PROJECT NO. 36-84510-1014
PROJECT: WESTWAY ADDITION

S/D No.: 86-16 Name: WESTWAY ADDITION

Re: S/D 86-16 - Preliminary Plat of Westway Addition.

Re: S/D 86-16 - Final Plat of Westway Addition.

Lot 1
Block 1
Westway

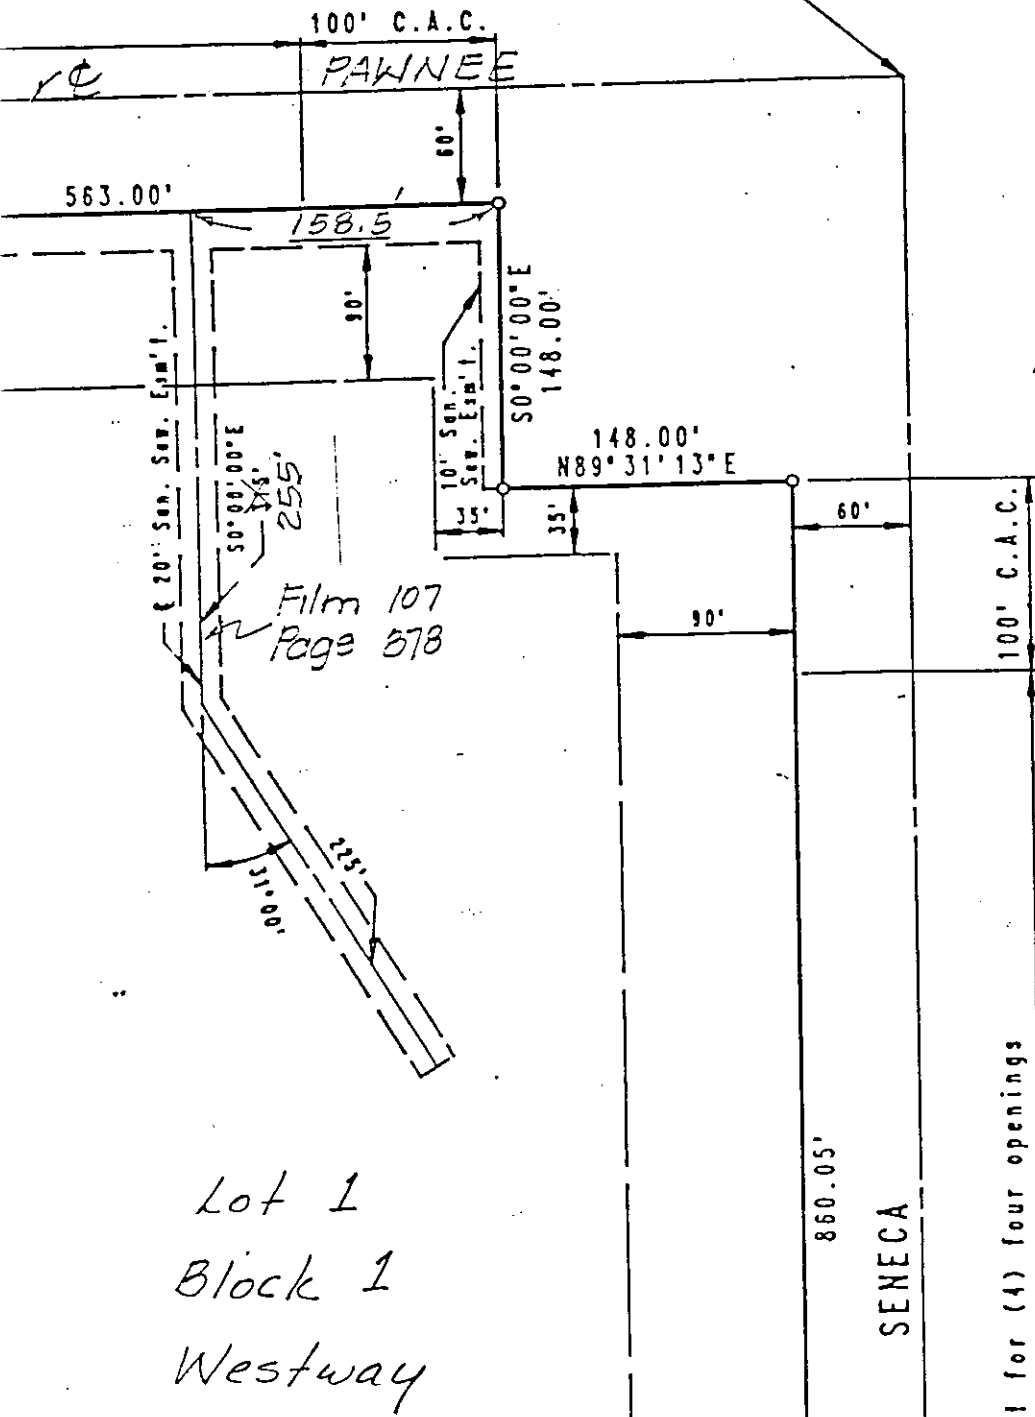
I have examined the final plat of Westway, an addition to Wichita, Sedgwick County, Kansas, and have found that a certain dimension error exists on the plat drawing showing the 20' sanitary sewer easement extending in a southerly direction located 158.5' west of the N.E. corner of Lot 1, Block 1, in said plat. The correction shall show a distance of 158.5' from the center-line of the 20' easement to the N.E. corner of said Lot 1, and the distance shown as S0°00'00"E, 315' shall be corrected to S0°00'00"E, 255'.

We, Professional Engineering Consultants, P.A., engineers in aforesaid county and state, do hereby certify that a certain dimension error exists on the plat drawing showing the 20' sanitary sewer easement extending in a southerly direction located 158.5' west of the N.E. corner of Lot 1, Block 1, Westway.

The recorded plat of Westway contains a dimension error on the sanitary sewer easement at the northeast corner of Lot 1. The plat dimension shown as 315' is from the Sec. line - not the property line. This dimension needs to be corrected to 255' (deducting the 60' street R/W).

Copy

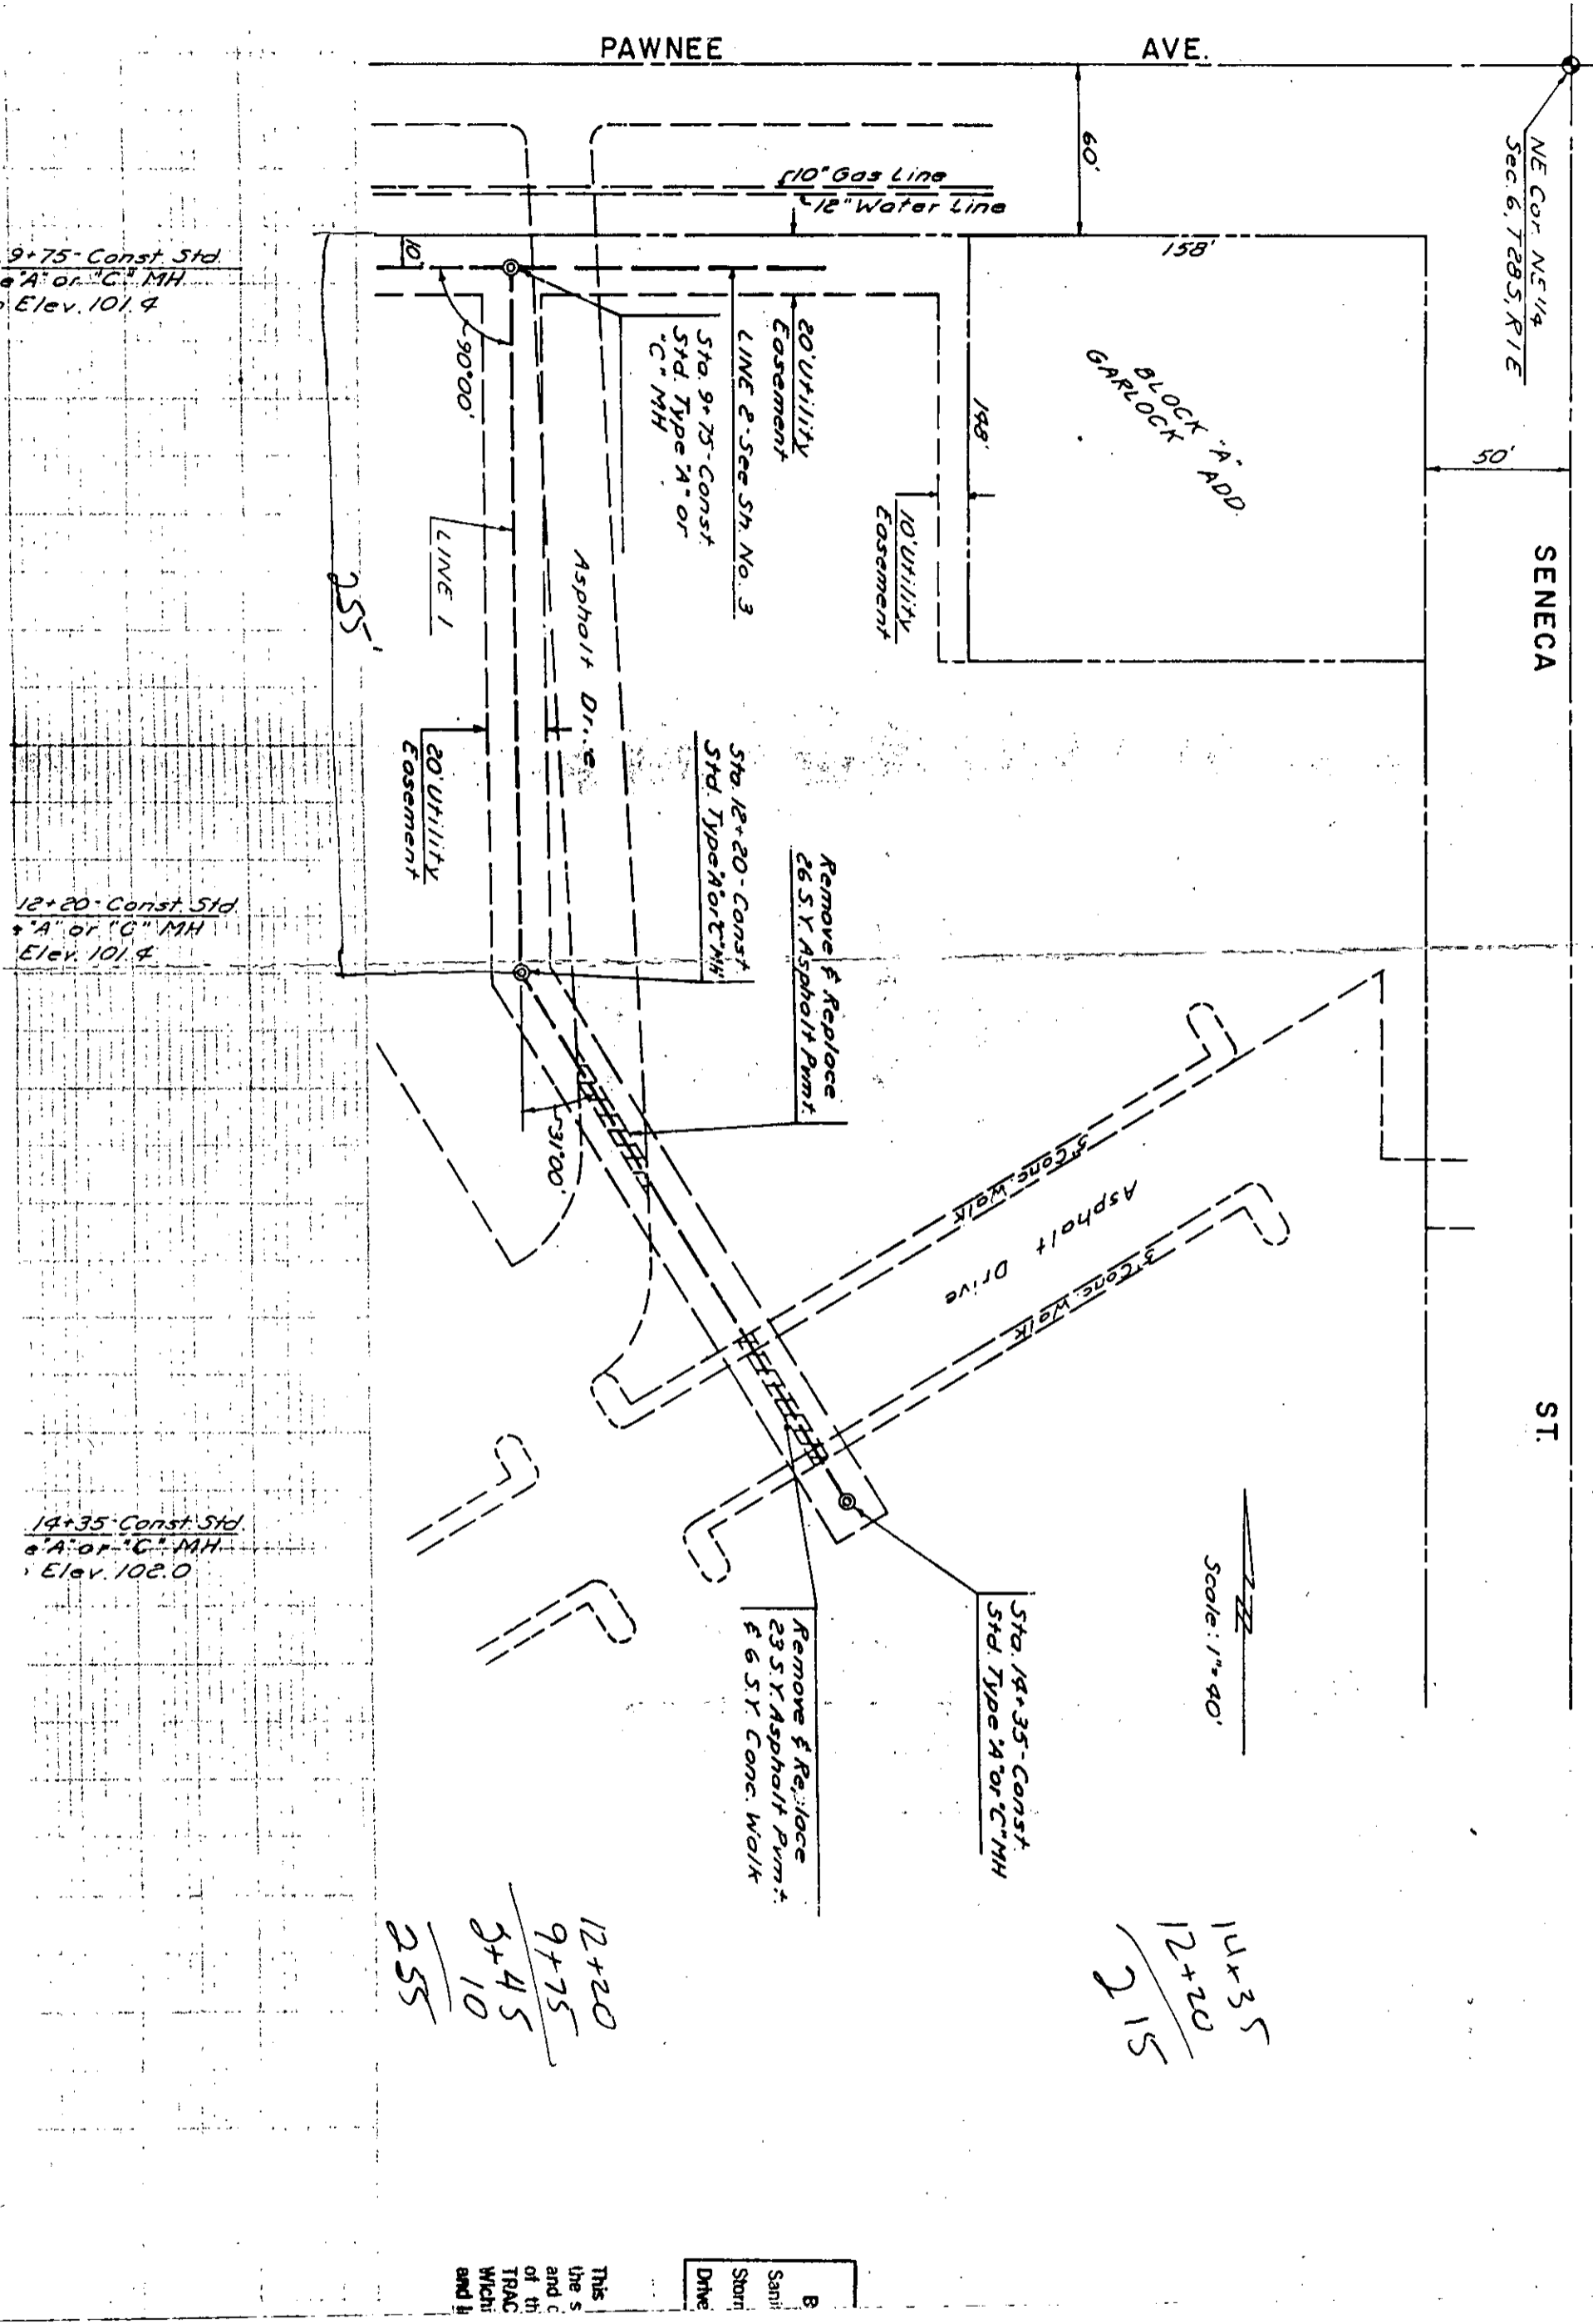
3. Westway Addition. Final Plat. Existing main in Seneca and Pawnee. Existing structure now served. PROBLEMS! 8" line shown is probably correct, however not all water lines are shown. Request 20' Utility esmt. for 8" main going west x SW from northerly end of 8" main shown. See notes on sketch plat. Consultant to determine location of 8" mains from Water Dept. City.
